UNITED STATES PATENT AND TRADEMARK OFFICE

APPLICATION NO.	FILING DATE	FIRST NAMED INVENTOR	ATTORNEY DOCKET NO.	CONFIRMATION NO.
09/737,279	12/14/2000	Seiji Hiroshima	MITS:024	7933

Office Action Summary

DETAILED ACTION

Fig. 1

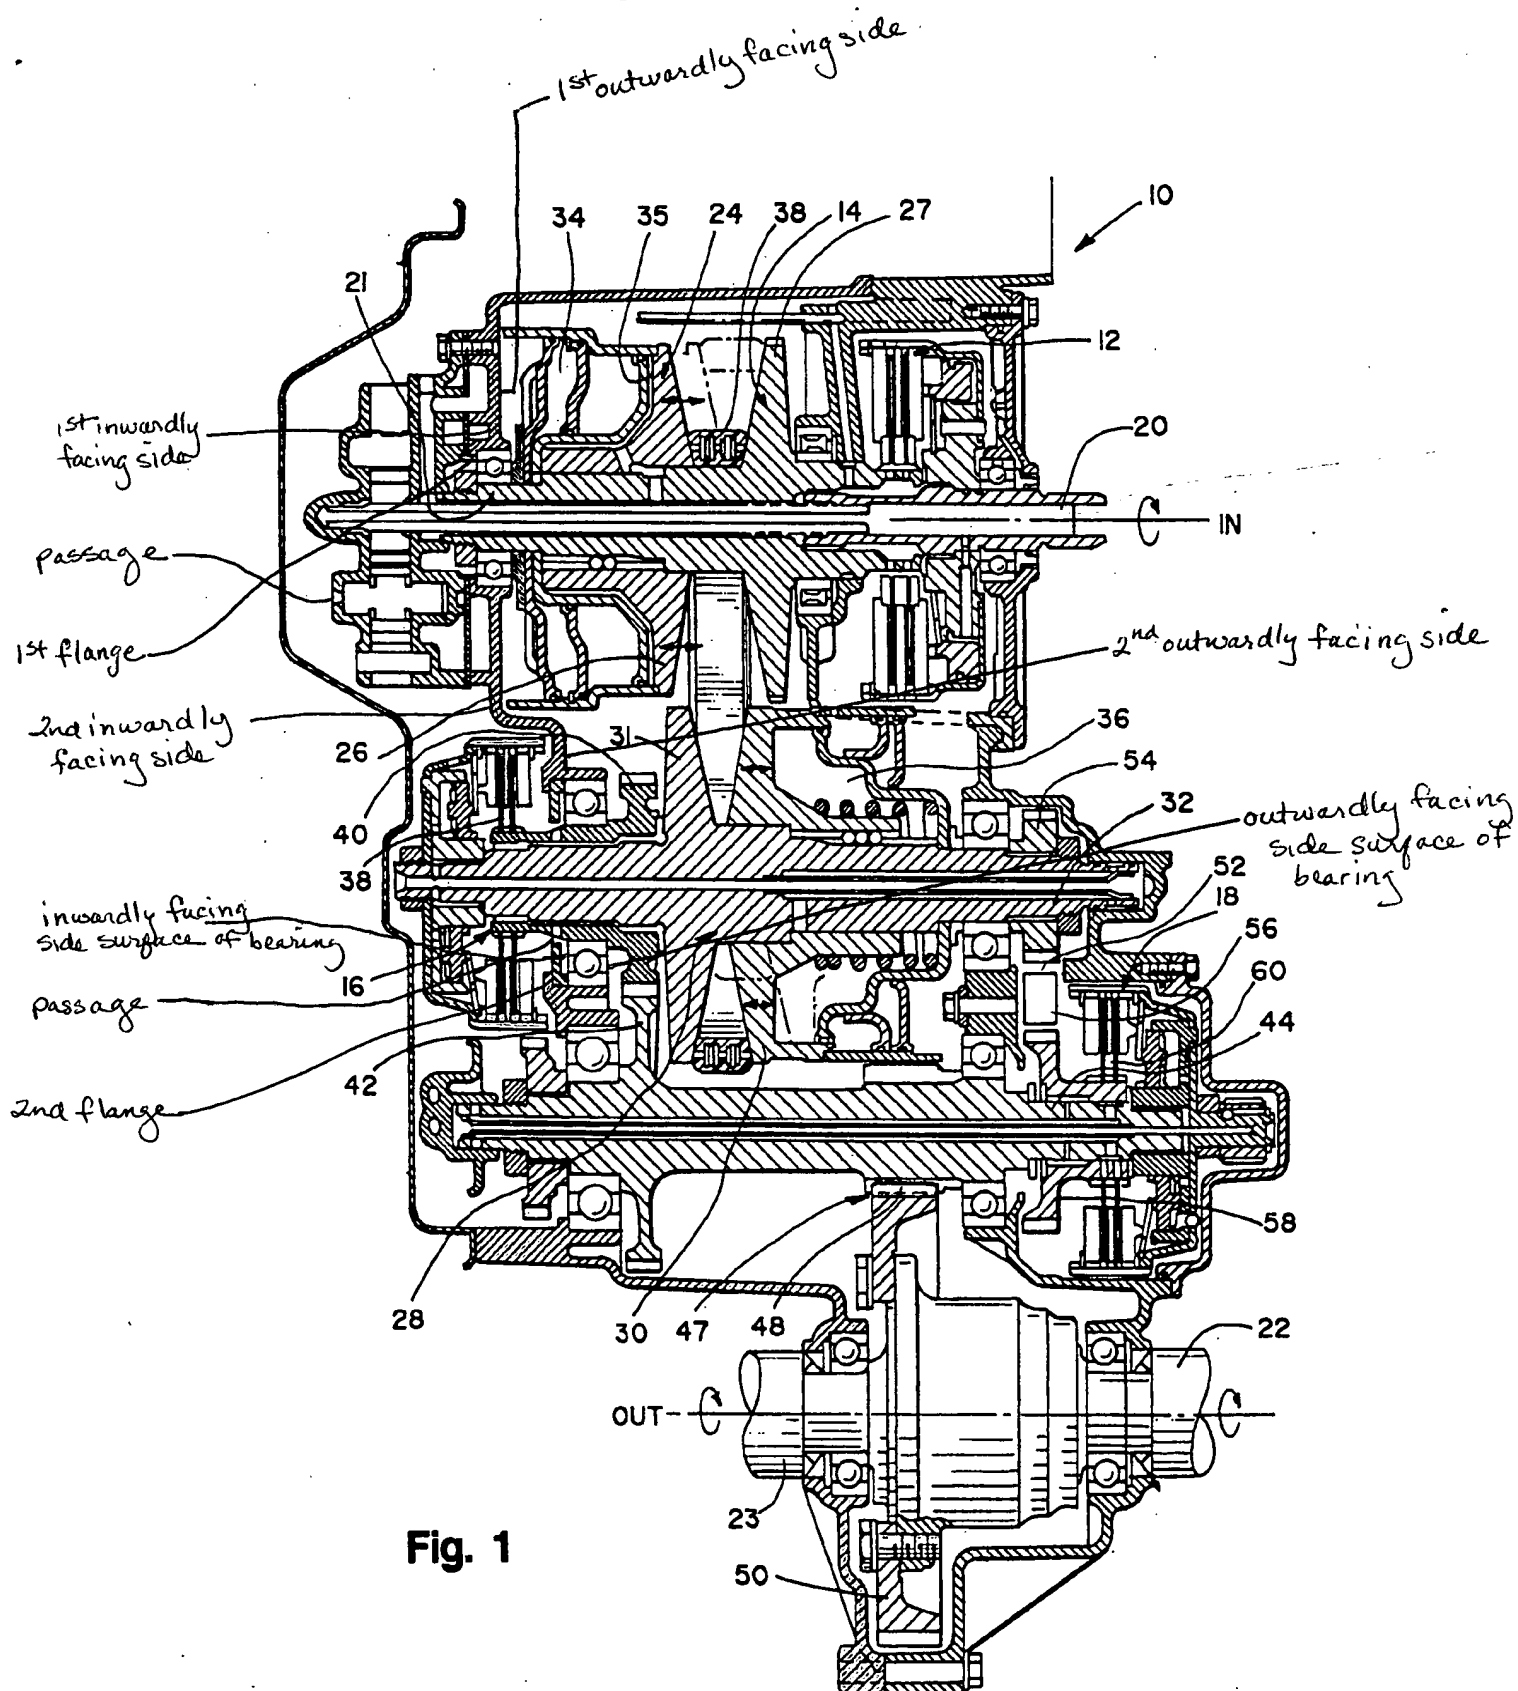
5. Claim 1 is rejected under 35 U.S.C. 102(b) as being anticipated by US Patent 5006092 to Neuman et al. Neuman et al. show in figures 1 and 2 a belt-type continuously variable transmission comprising: a continuously variable transmission mechanism comprising: a primary shaft 20 having a primary pulley 24; a secondary shaft 32 having a secondary pulley 28, and an endless belt 33 wound on the primary pulley and the secondary pulley, a housing (outlined in blue in the attached copy of figure 1) that accommodates the continuously variable transmission mechanism, the housing having an end wall that is formed with a first bearing mounting hole through which one end portion of one 20 of the primary shaft and the secondary shaft penetrates, the end wall having a first outwardly facing side as labeled and a first inwardly facing side as labeled opposite to the first outwardly facing side around the first bearing mounting hole, a first bearing (outlined in yellow in the copy of figure 1) fitted in the first bearing mounting hole and allowing the one shaft 20 to be supported rotatably by the end wall, a flange (indicated by the Examiner in the copy of figure 1) extending radially from the first inwardly facing side toward the first bearing mounting hole, a bearing retainer (outlined in red in the copy of figure 1) provided on the first outwardly

facing side of the end wall and projecting radially inwardly toward the first bearing mounting hole and engaging the first bearing to pinch the first bearing against the first flange as shown, and a first cover (outlined in yellow in the copy of figure 1) that is connected to the housing (at the bottom of the figure 1) and covers the one end portion of the one shaft and the bearing retainer.

Re: claim 7. Neuman et al. show in figure 1 the transmission comprising a second flange as labeled in the attached copy of figure 1, the end wall having a second outwardly facing side as labeled in figure 1 and a second inwardly facing side as labeled in figure 1 opposite to the second outwardly facing side around the second bearing mounting hole wherein the second flange extends radially from the second inwardly facing side toward the second bearing mounting hole, the second cover contacts via the outer side surface of the second bearing (to the same extent as shown in figure 1B of the instant application) the second outwardly facing side of the end wall and an outer side surface of the second bearing in the same plane, the depth of the second bearing mounting hole (which includes the space occupied by the second bearing) which extends in the axial direction is shorter than the combined thickness of the second bearing and the urging member in a free state, which combined thickness extends in the

Neuman et al. show in figure 1 the first and second covers having passages as indicated by Examiner in the copy of figure 1 attached to the Action. In this case the first cover is shaded in orange and is shown to the left of the first bearing shaded in yellow. This first cover is connected to the housing as shown and covers the one end portion of the one shaft and the bearing retainer as shown. Hattori teaches the use of passages 64 and 13d as shown in figure 1 being oil passages through which oil is supplied to the continuously variable transmission mechanism. It would have been obvious to one of ordinary skill in the art at the time the invention was made to have modified the passages of the covers of Neuman, as modified, to have included oil passages, as taught by Hattori, as it is well-known in the art to provide covers with passages in order to provide a means of transporting a working medium, for example, oil throughout the mechanism for lubricating purposes.

9. Applicant's arguments filed 1/21/03 have been fully considered but they are not persuasive. With respect to the arguments regarding the second cover of Neuman et al. it is noted that the structure shaded in green in the attached copy of figure 1 represents the second cover. When shaft 32 is braked by the engagement of the disks

shown in the area of element number 38, the green shaded structure functions as a connected structure with the left side of the green shaded structure covering the end portion of the shaft and the right side of the green shaded structure engaging the outwardly facing side surface of the second bearing. In another perspective, it is noted that the claim language states that the cover covers "the one end portion of the one shaft" and that the one end portion is the portion of the shaft that penetrates the bearing mounting hole as claimed in lines 7-8 of claim 10. In light of the claim language it is noted that element 40 covers the one end portion (the end or outer periphery of the section of the shaft that penetrates the bearing mounting hole) as shown. The remaining arguments are moot due to the new interpretation including a new labeled version of figure 1 of the Neuman et al. reference.
